## Addendum No. 3

**Project:** 2016 Addition & Renovations  
**North Harrison Middle School**  
Ramsey, Indiana

**Proj. No:** 1518.01

**Date:** December 10, 2015

Area "A" - 2nd Floor  
Demolition Plan

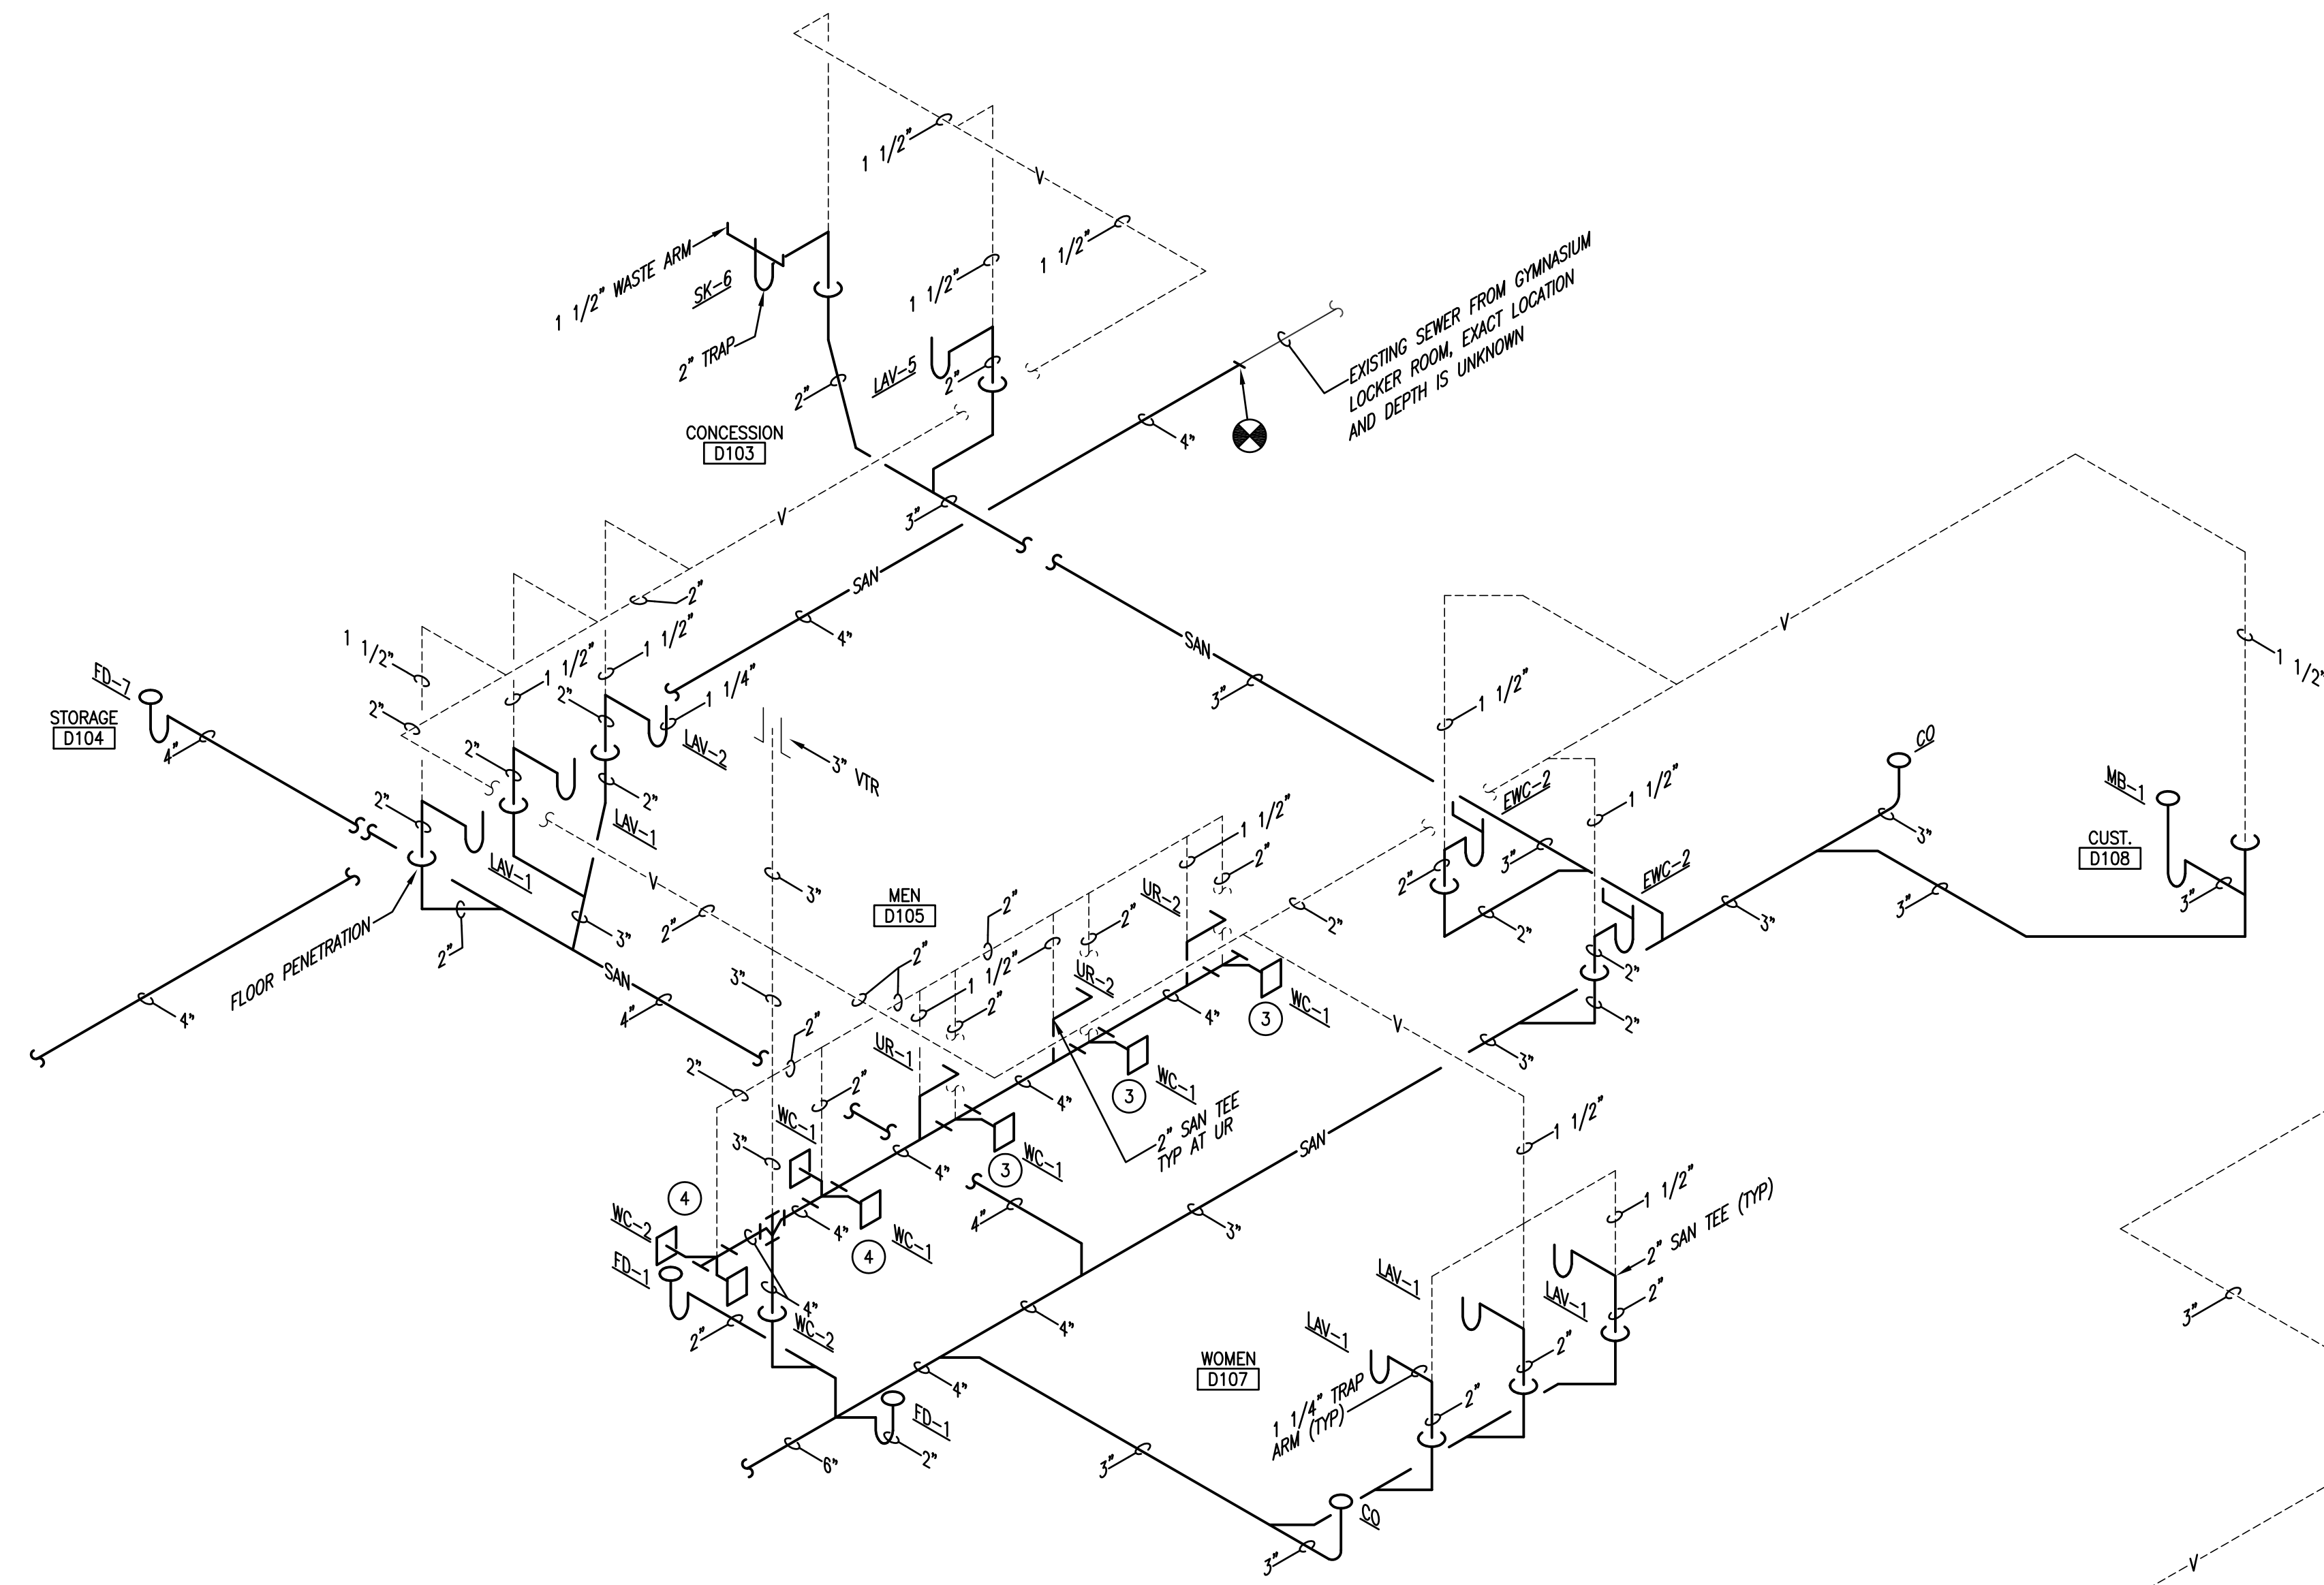
5. All A-000 Series (Architectural Demolition) Sheets  
Demolition Plan Keynotes have been revised. Refer to reissued Sheet A-004 included with this Addendum for revisions. Changes apply to all sheets.

6. Sheet A-001  
Add Keynote D62 to central main corridor. Note applies from main entrance to Cafeteria.
7. Sheet A-004  
Replace existing drawing in its entirety with the attached Drawing; refer to clouded area for revisions.

DRAWING ISSUED VIA ADDENDUM 3  
**2 SOIL & WASTE RISER DIAGRAM - AREA D**  
 P402 SCALE: NONE

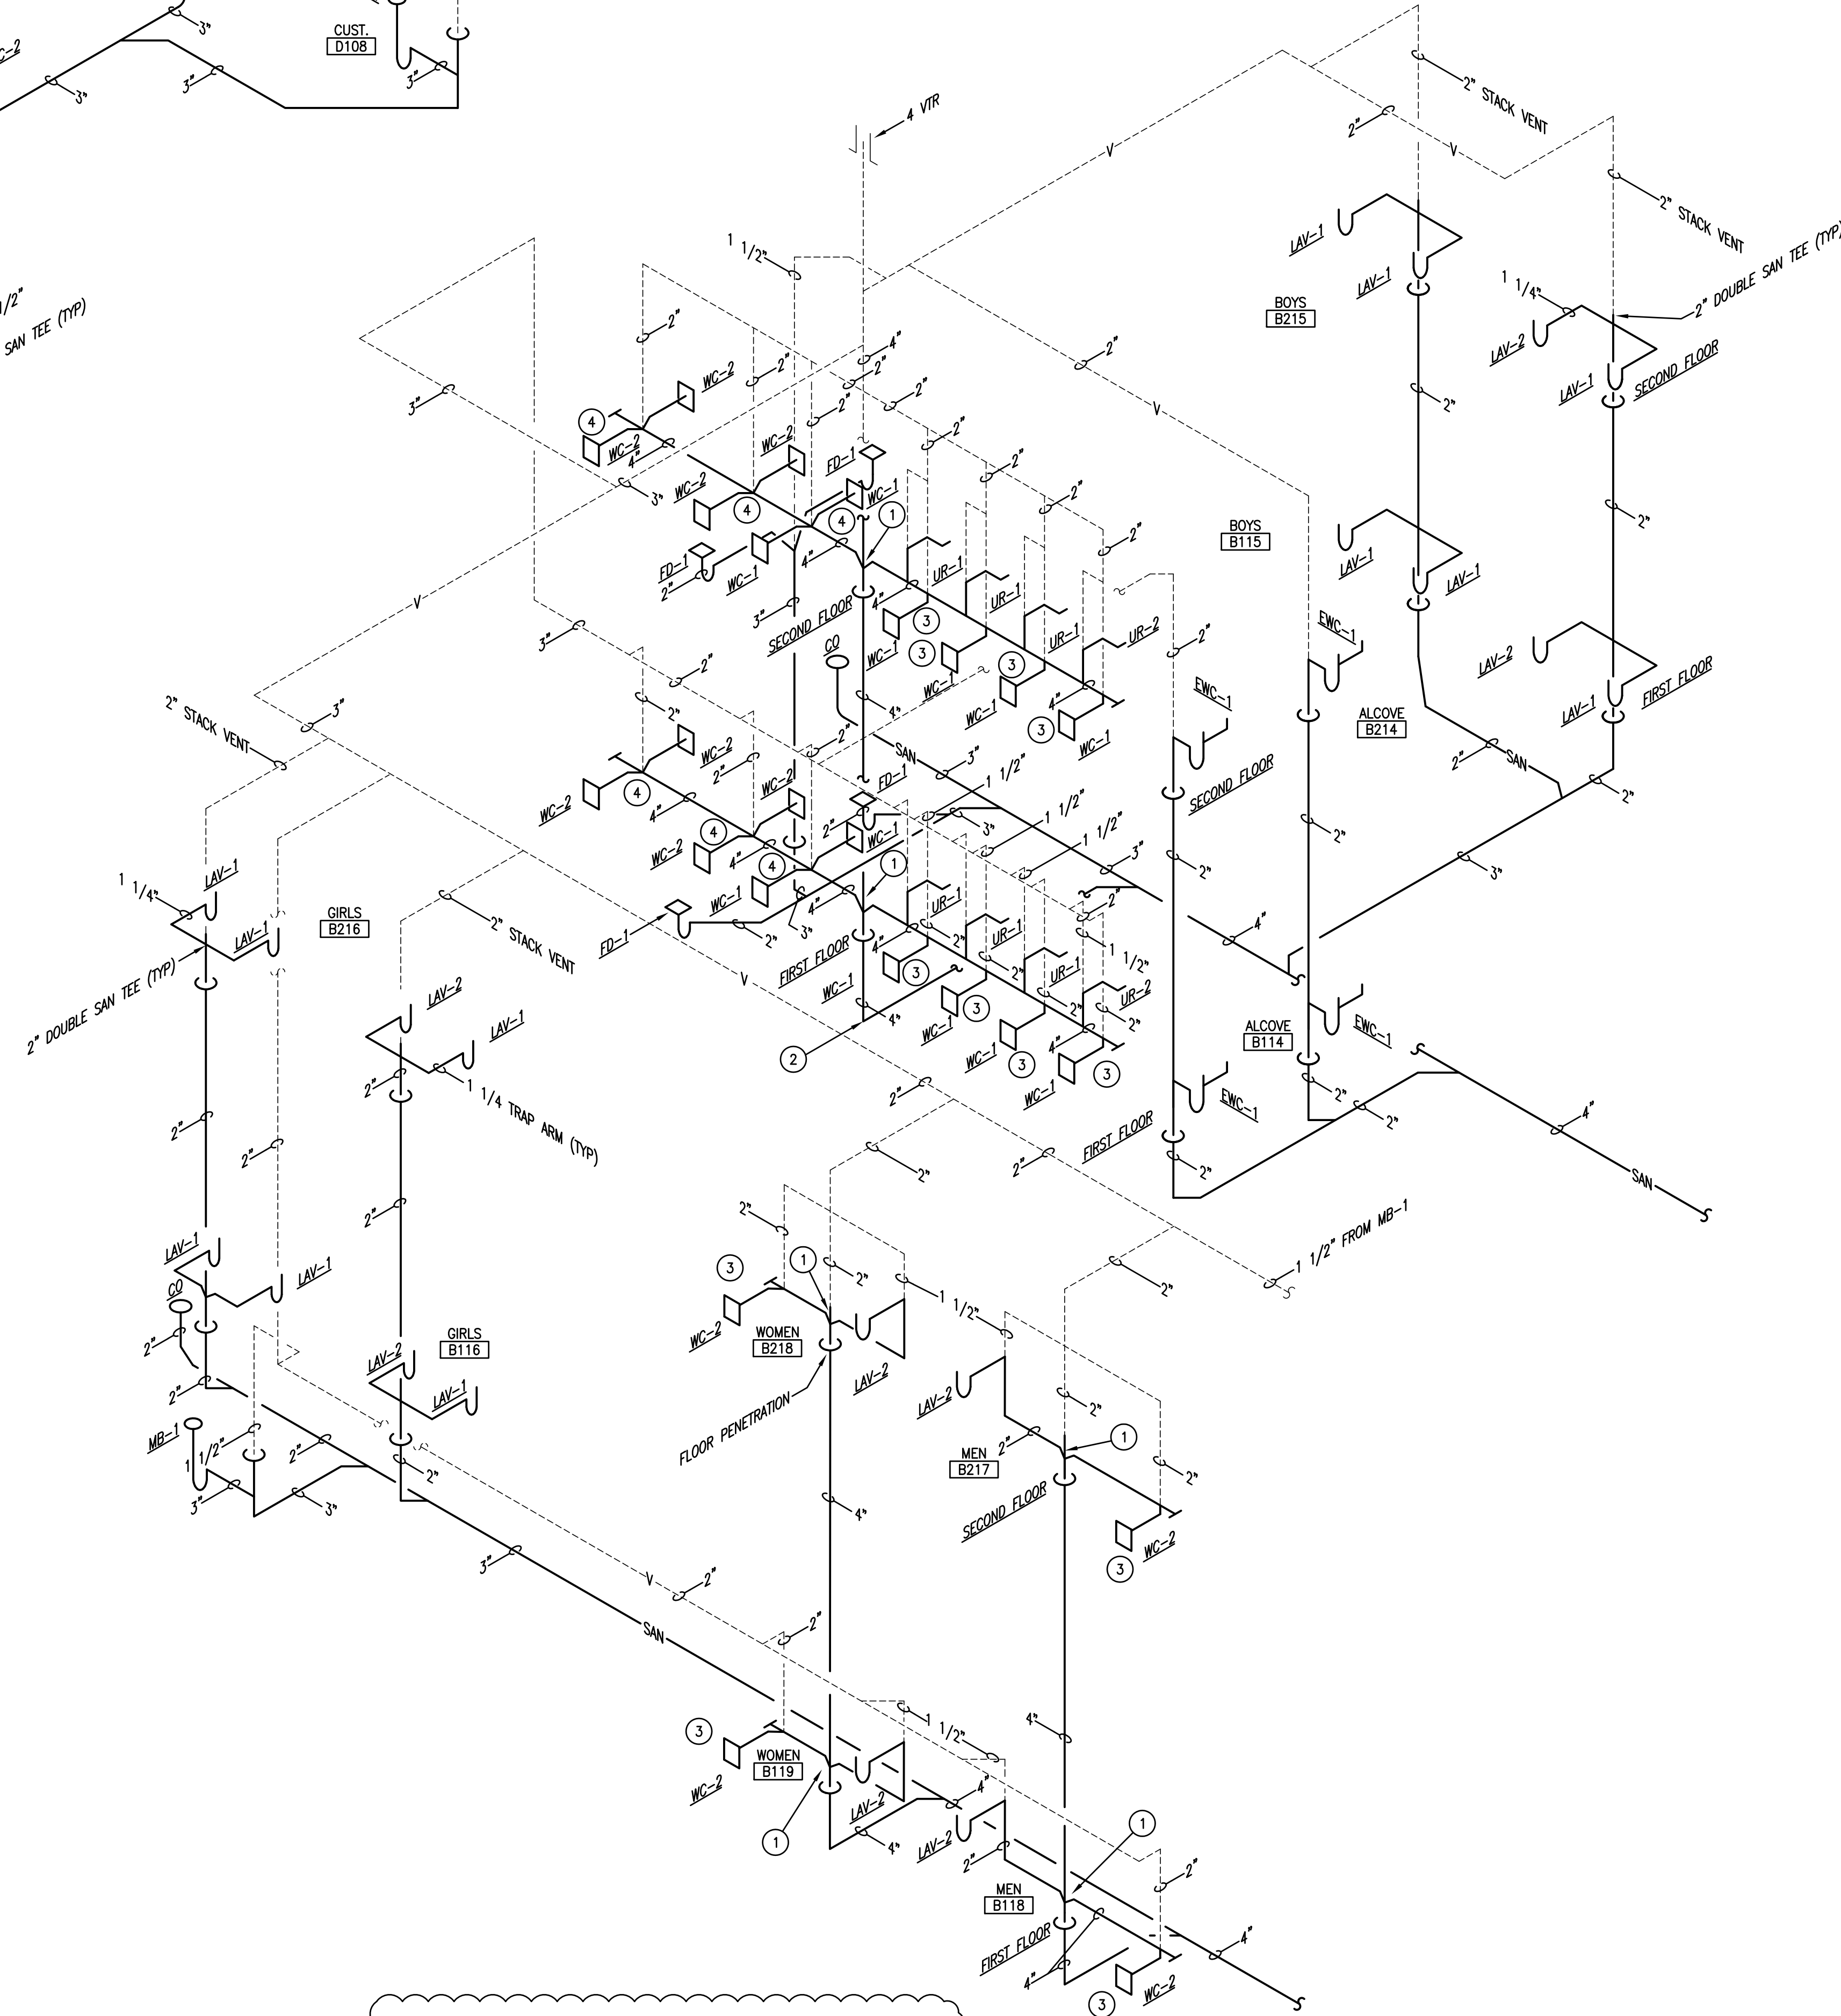
29. Sheet P-302  
"Drain and Miscellaneous Schedule:" Delete floor drain FD-8.
30. Sheet P-402, Soil and Waste Riser Diagrams  
Add the attached Drawing in its entirety.

**I Academic Locker Base**  
A-901 SCALE: 3/4" = 1'-0"

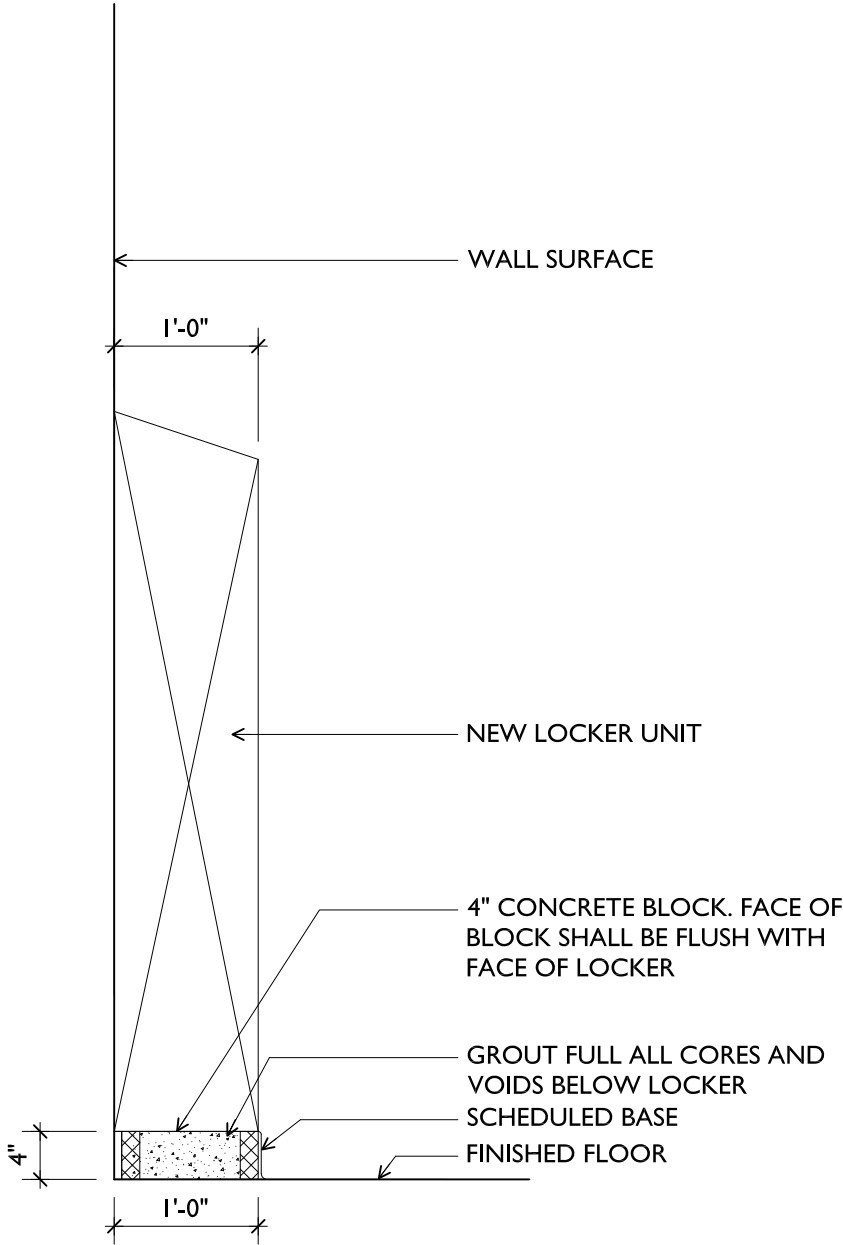
17. Sheet A-802  
Details 27, 28, and 29, shift curtain wall in wall to bypass CMU as shown on Wall Section 4/A-703.
18. Sheet A-901  
Add Detail 1, Academic Locker Base per attached Drawing AD-3.1.

# Partial West Elevation

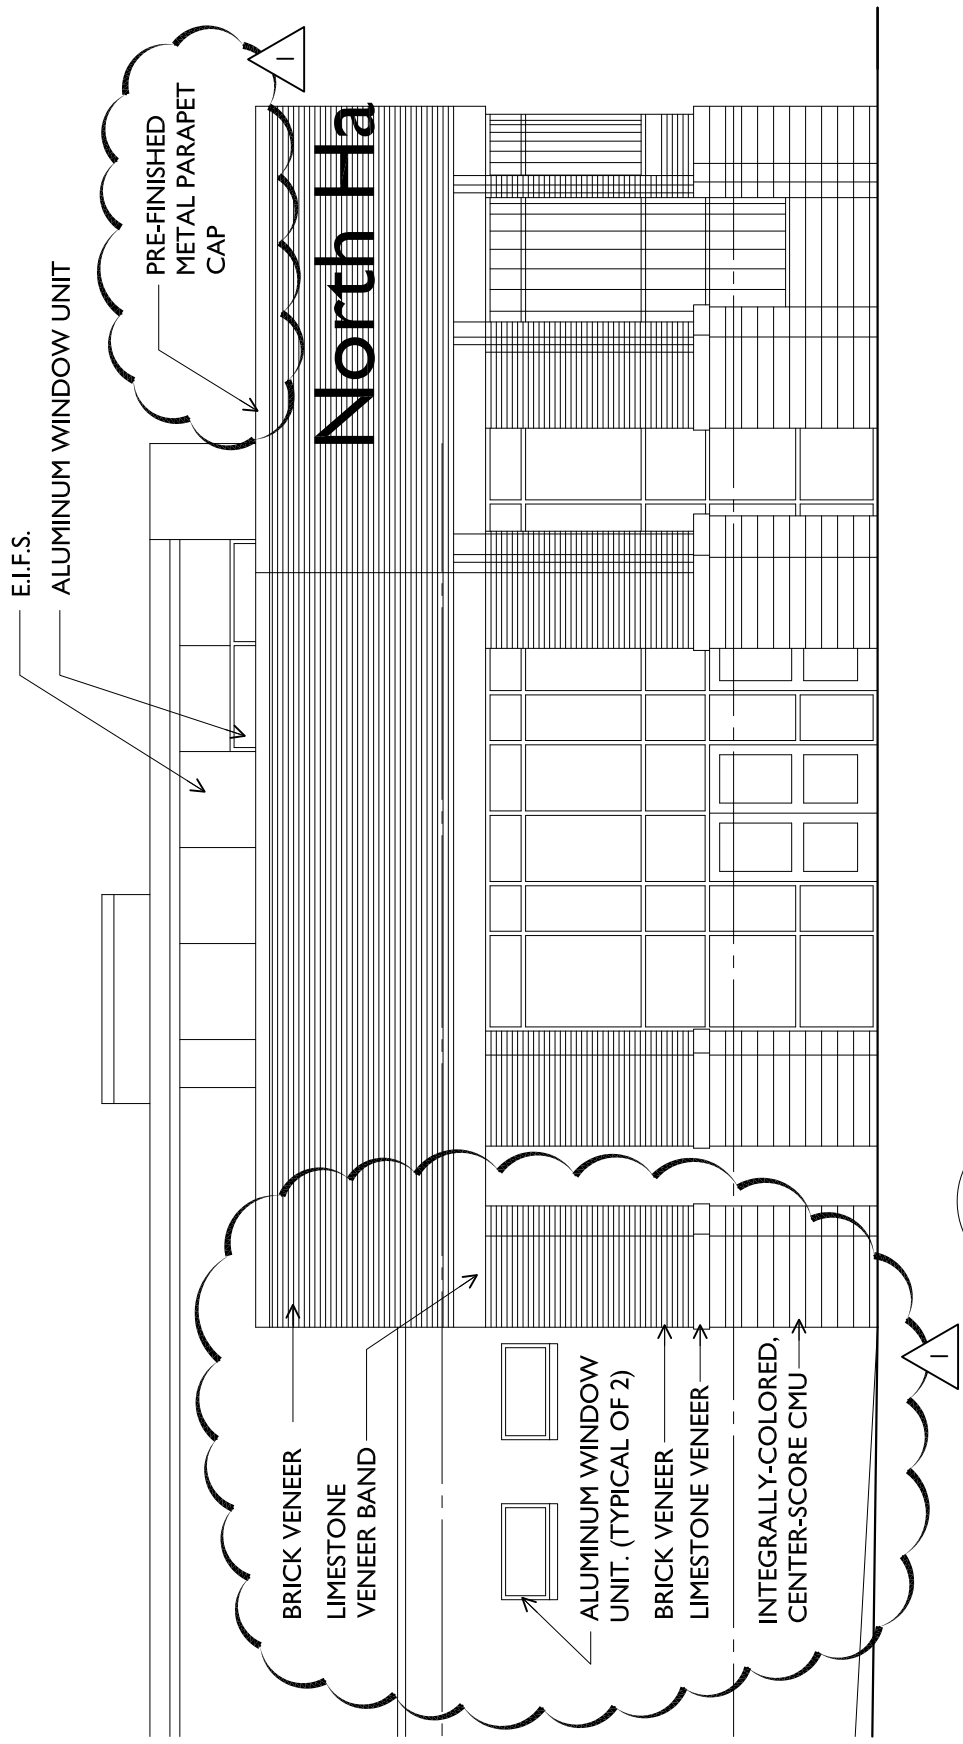
12. Sheet A-502  
Detail 1, Partial West Elevation, add notes at entry canopy per attached Drawing AD-3.2.  
Detail 4, Partial North Elevation, revise all notes referring to "Center Score CMU" to read "Integrally-Colored, Center Score CMU."

**1**  
**PLUMBING FOUNDATION**  
**PLAN - FIRST FLOOR - AREA 'D'**  
P-104 SCALE: 1/8" = 1'-0"

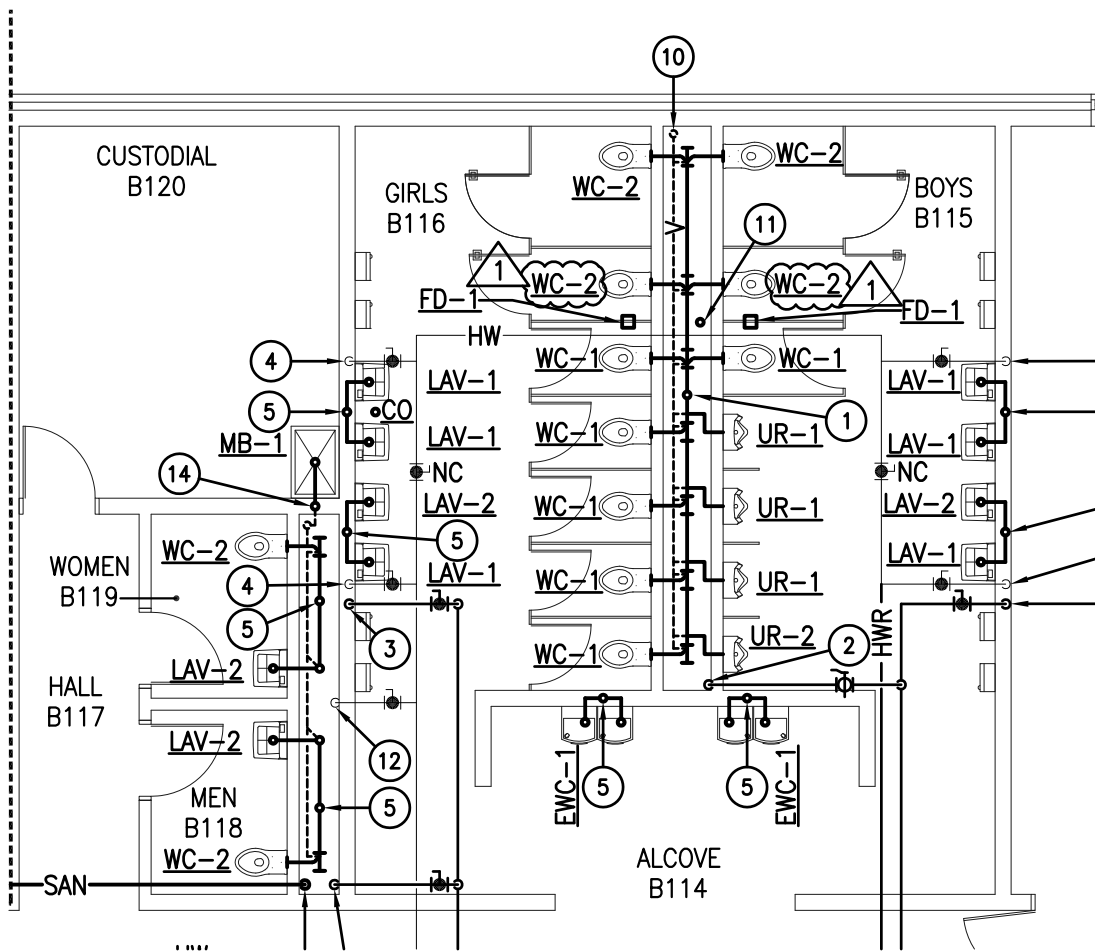
23. Sheet P-103  
Add attached Drawing AD-3.4 in its entirety. Drawing changes Reference Note 3 to 9.
24. Sheet P-104  
Add attached Drawing AD-3.5 in its entirety. Drawing adds pipe sizes to below floor sanitary piping.
